Re: Docket No. CSC 461A - Greenwich Substation and Line Project, Development and Management Plan, Vol. 1, Part 1- Cos Cob Substation Modifications

Response to CSC-01 Interrogatories dated 03/19/2018
CSC-001, 002, 003, 004, 005, 010

**Data Request CSC-01
Dated: 03/19/2018**

BY: PS (PEI)	CHKD: APP	APP: APP
DATE: DATE	DATE: DATE	DATE: DATE
H-SCALE: 1"=30'	SIZE: D	FIELD BOOK & PAGES:
V-SCALE: 1"=30'	V.S.:	R.E. DWG:
R.E. PROJ. NUMBER:	DWG NO.:	15706-10036

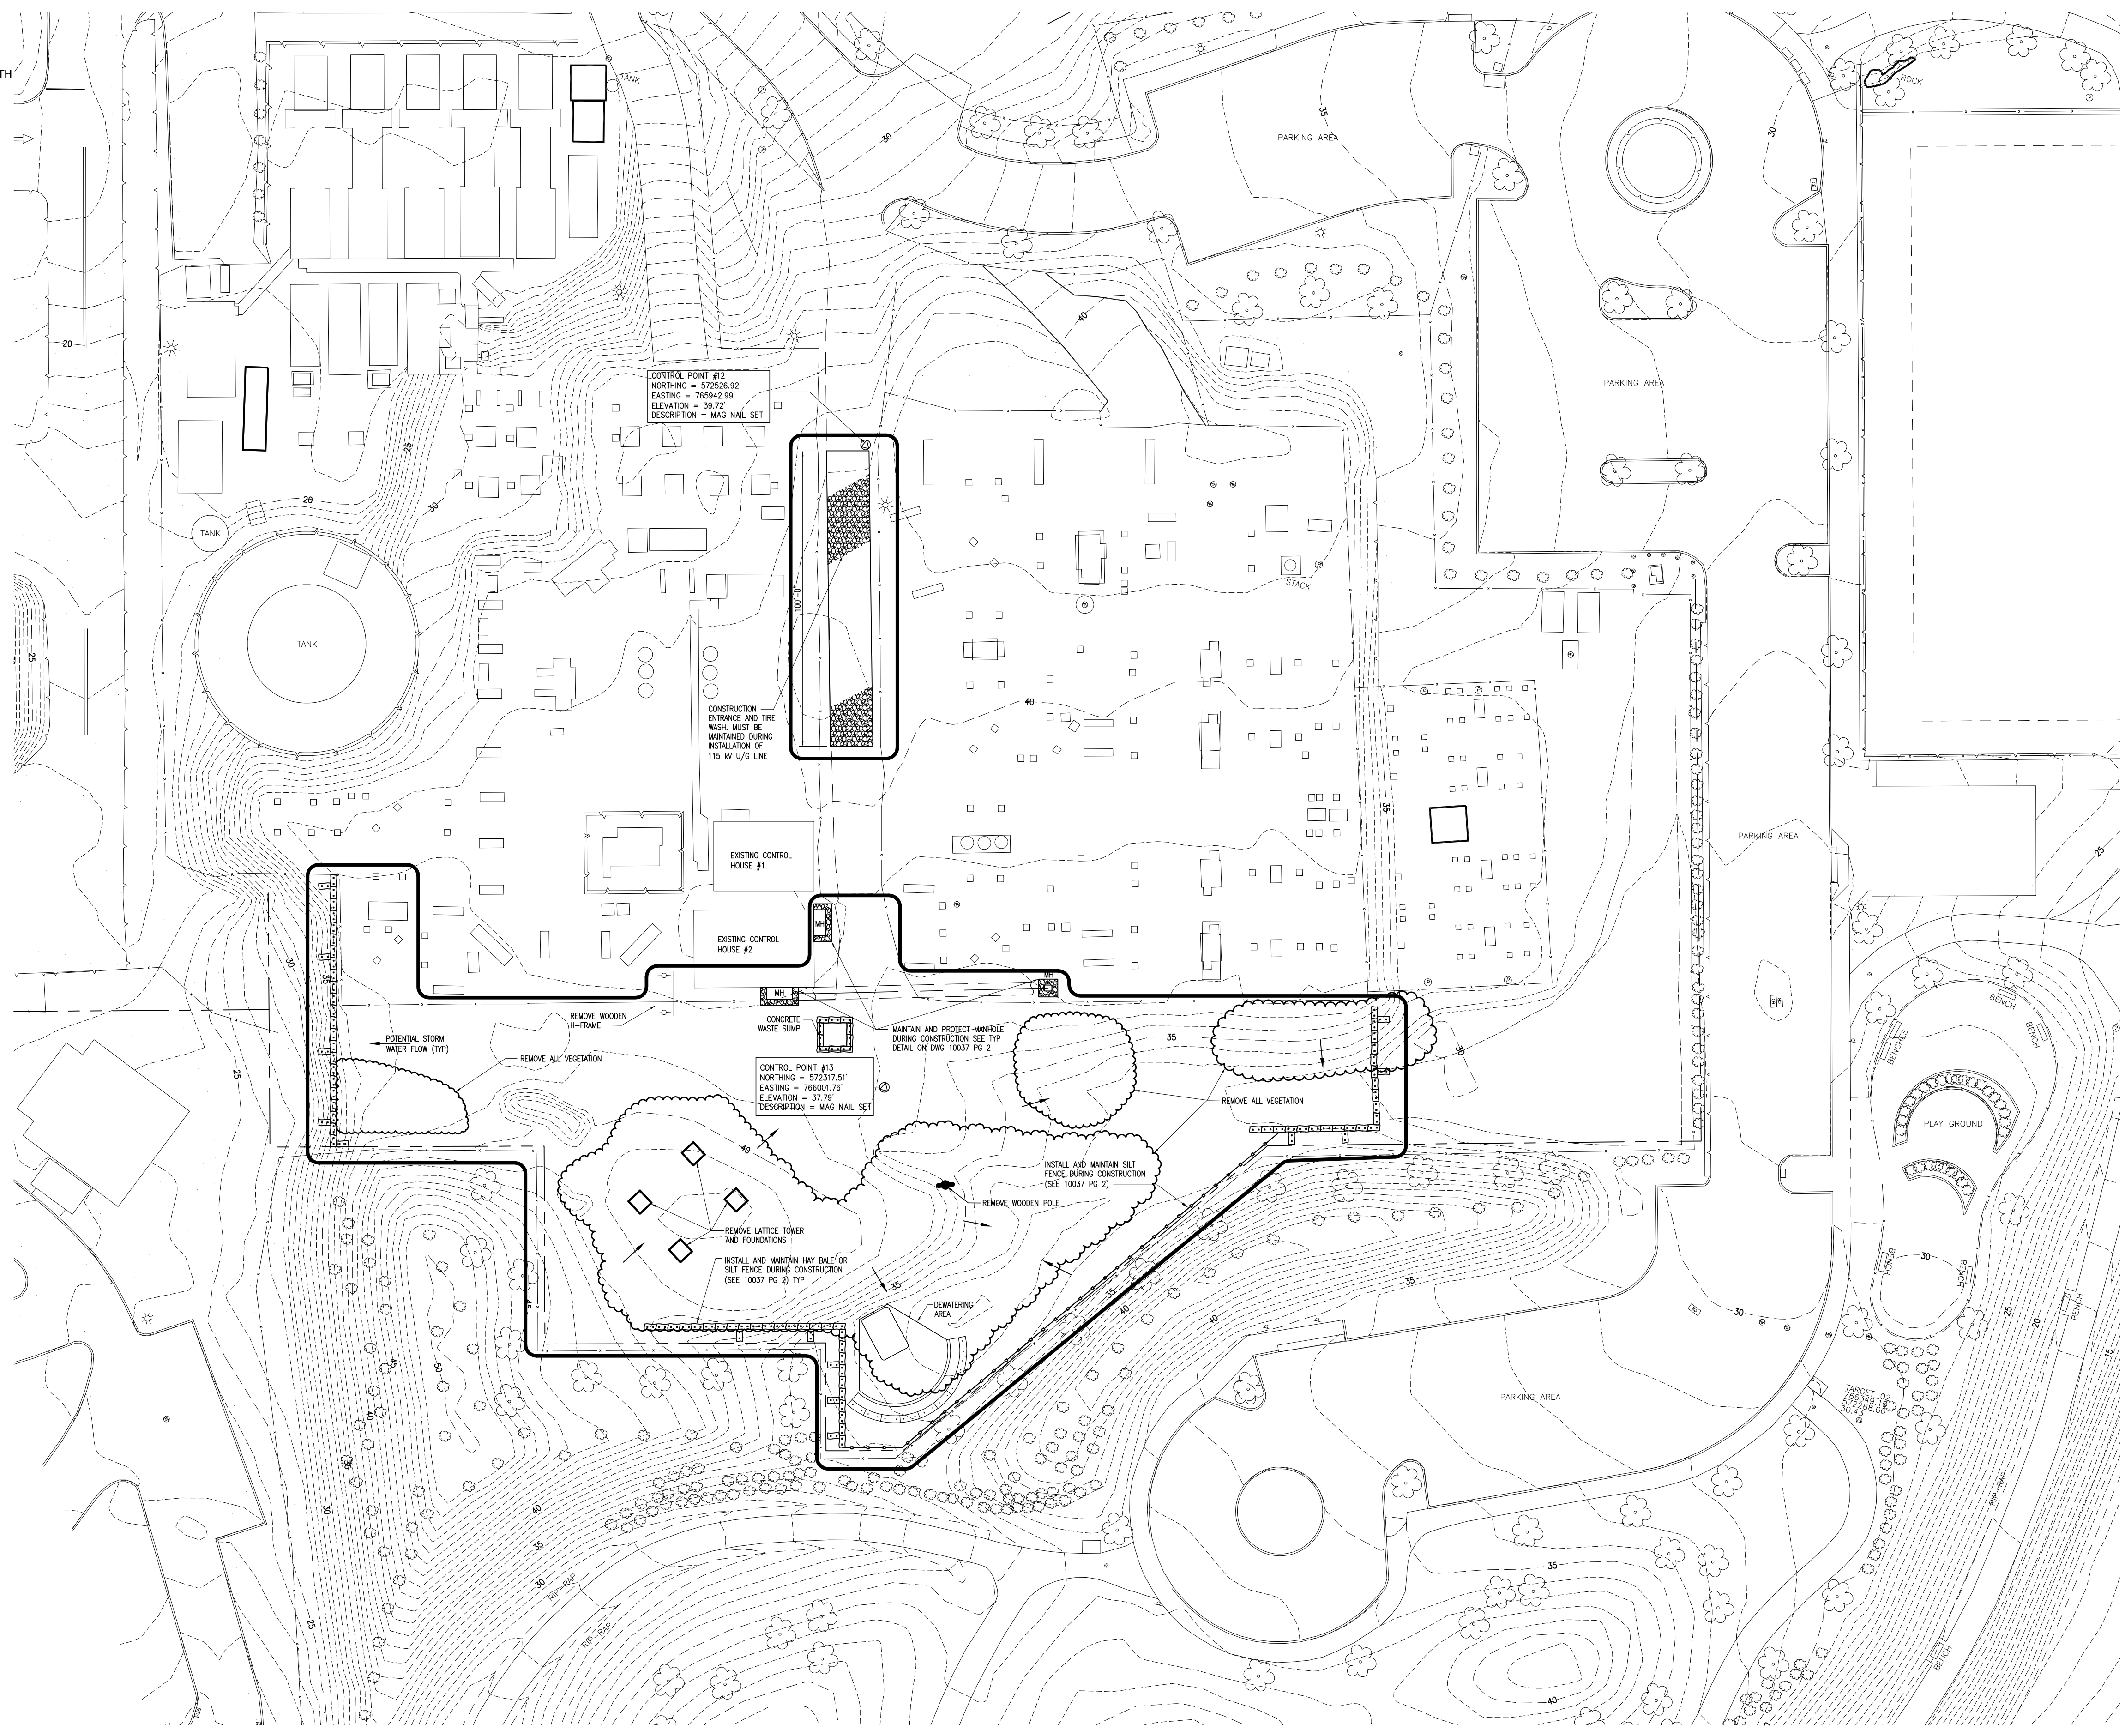
- a. sedimentation barriers along the west edge of the expansion area do not extend to the southwest corner. What is preventing stormwater from potentially flowing downslope to the adjacent property?

- b. partial sedimentation barriers are shown along the south edge of the expansion area. What is preventing stormwater from flowing east from the southwest corner of the retaining wall along an existing drainage area and into a landscape area of Cos Cob Park? Similarly, what is preventing stormwater from flowing south from the dewatering basin area across a generally flat area onto the paved walkway in Cos Cob Park?

- c. hay bales and silt fence are noted in certain areas but there is no indication which one is upgradient from the other, or the installation distance between the two barriers. Please clarify.

- d. provide a drawing that shows potential stormwater flows from the construction area and methods for containing such flows. Please use arrows depicting such flows.

- e. D&M Plan narrative p. 29 states migration of contaminated soils would be controlled by E&S controls; however, the construction site perimeter is only partially enclosed by E&S controls. How would soil migration be prevented in areas where there are no perimeter E&S controls? Please explain.

- a., b., and c: The stormwater flows during construction are not expected to change from current conditions. E&S controls will prevent stormwater and sedimentation from flowing onto adjacent property that is at a lower elevation than the construction site. The E&S controls depicted on attached Drawing No.15706-10036 have been extended to all areas where the elevations of the adjacent property is less than or equal to that of the proposed construction area for the expanded substation. The silt fence has been extended across the southern property line, to protect against the flow of stormwater onto the Cos Cob walkway.

- d. Please attached Drawing No. 15076-10036 depicting the current direction of stormwater flows on site. The existing stormwater flows are not expected to change during construction and they are anticipated to improve somewhat (i.e., reduced flow toward adjacent property) due to the number and size of foundation excavations and grading.

e. E&S controls will be deployed in all areas where the adjacent property is at an elevation that is less than or equal to the proposed construction area. See Note 4.1 on attached Drawing No.15076-10037 PG1 for detail on inspection and maintenance practices.

**PAVED ROAD WITH CURB ONE SIDE
CROSS SECTION**

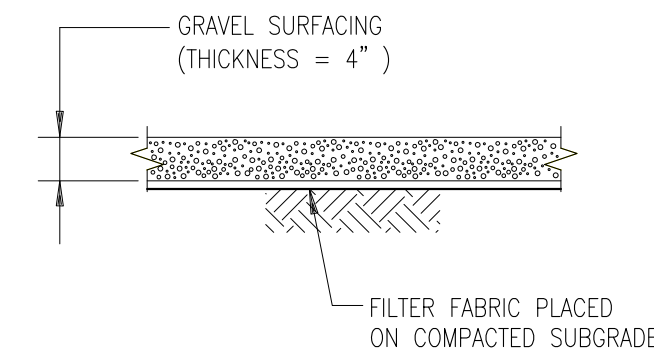
Question:
Provide a cross-section detail for the new paved substation access road.

Response:
Please see attached Drawing No. 15706-10038 PG2.
